Red = October additions Struck-out = October deletions Green = January additions Struck-out = January deletions

Numbers after additions & deletions refer to Comments in August Matrix [1 - 222] ;
[E] refers to EPC Comments; [S] refers to Staff Recommendation

C. Traffic Movement, Access Management, and Roadway Design

Figure C-3: Example 6-Lane Typical Sections with CURBSIDE Bus/BRT Lanes for COORS BOULEVARD/COORS BYPASS (NM45)

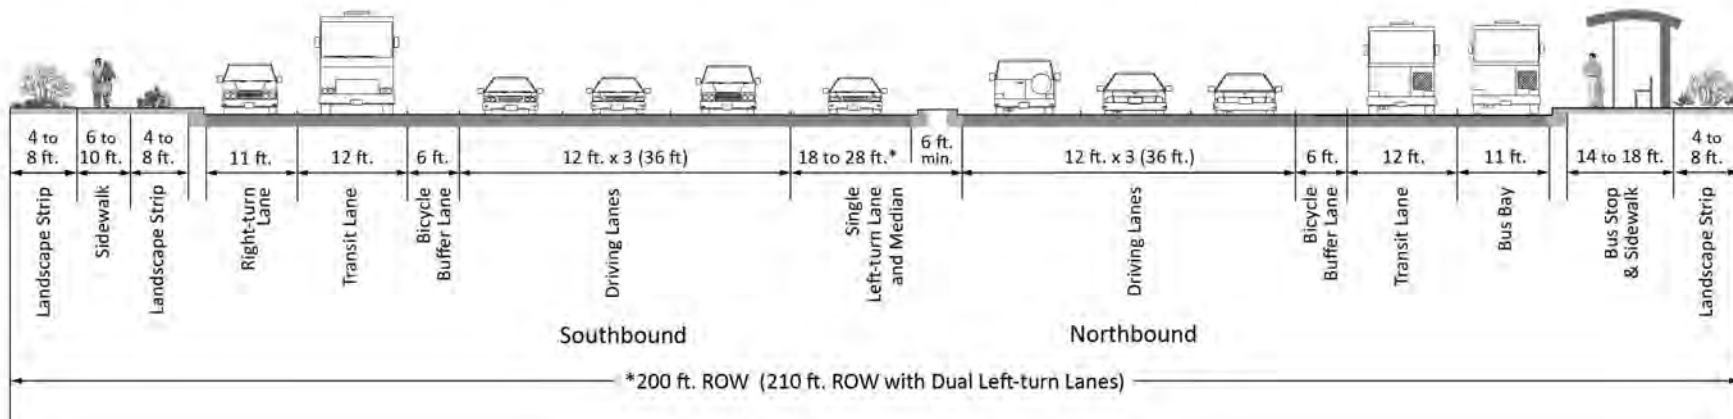
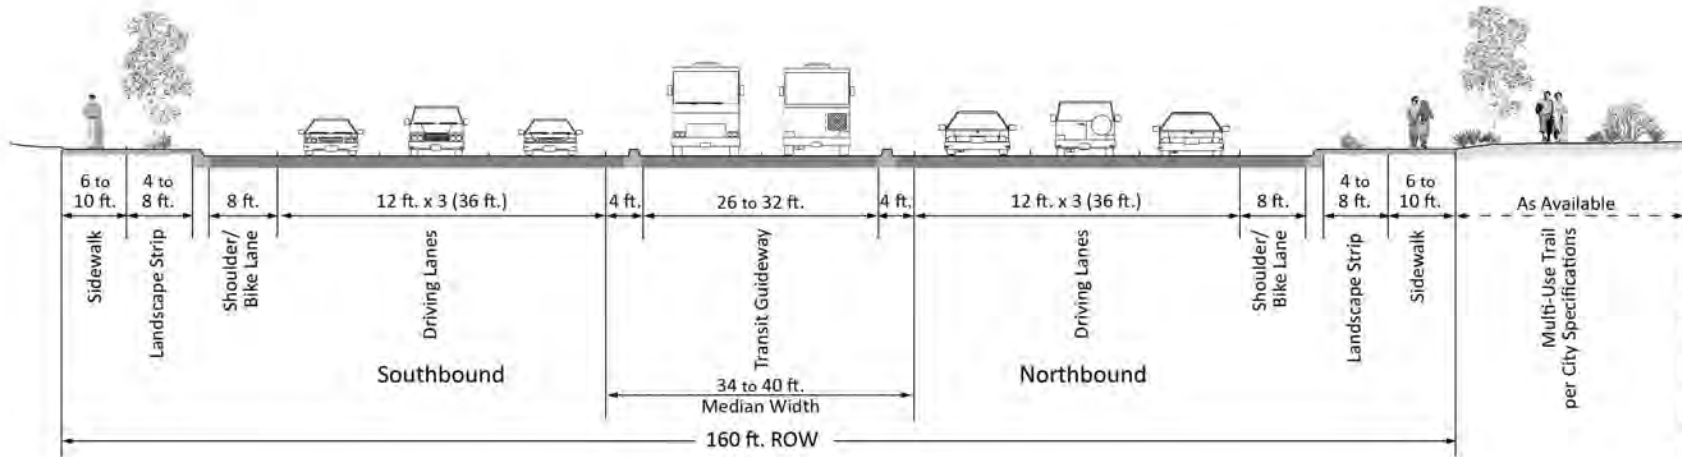
B. Section at Intersection with curbside BRT Station (see 4.2) [37]

Note 1: Minimum 10 foot sidewalks are required in Major Activity Centers and Community Activity Centers as defined in the Albuquerque/Bernalillo County Comprehensive Plan.
Note 2: The location of the bicycle lane and transit lanes may be reversed, based on the latest best practices and knowledge at the time these lanes are designed.

Figure C-4: Example 6-Lane Typical Sections with MEDIAN BRT Lanes for COORS BOULEVARD/COORS BYPASS (NM45)

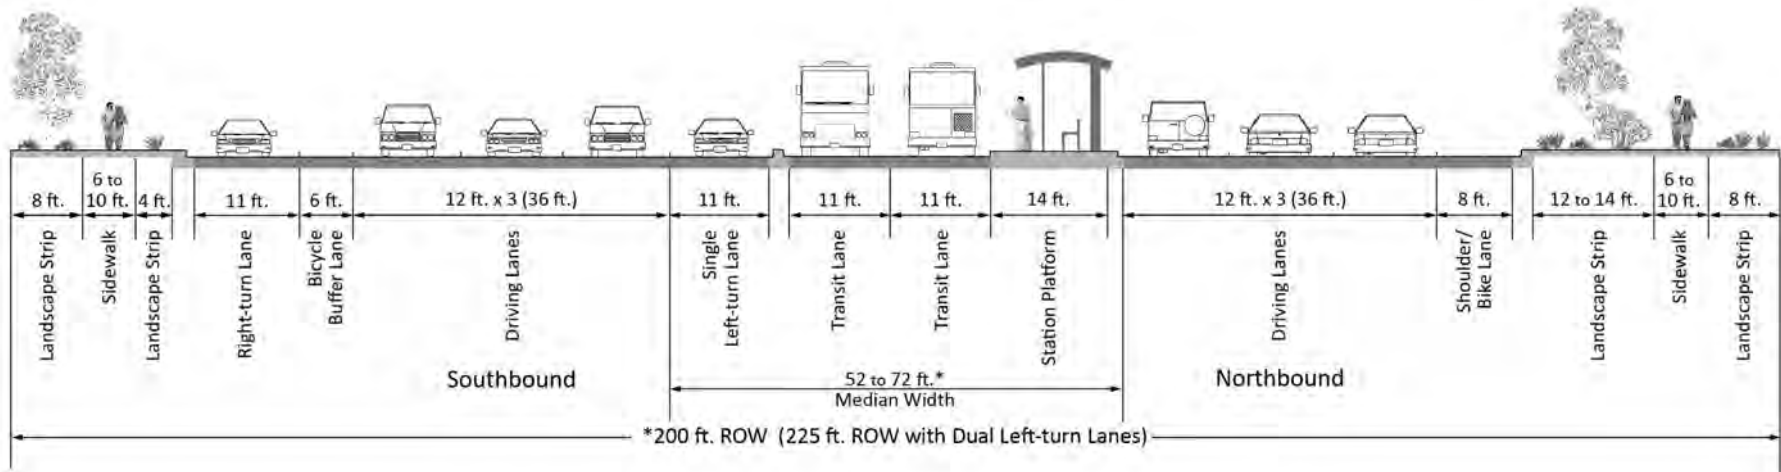
B. Section at Intersection with Median BRT Station (see 4.2) [37]

Figure C-5: Example 4-Lane Typical Section for COORS BOULEVARD from Coors Bypass to Alameda Boulevard (NM448)

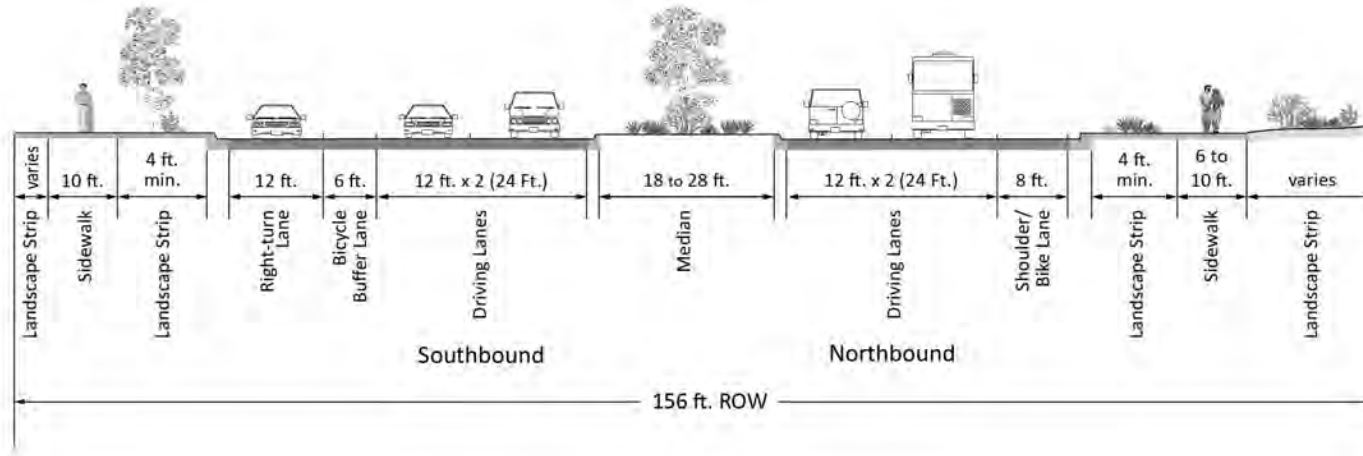
Notes: 1) Minimum 10 foot sidewalks are required in Major Activity Centers and Community Activity Centers as defined in the Albuquerque/Bernalillo County Comprehensive Plan. 2) Transit vehicles also use southbound driving lanes. [31]
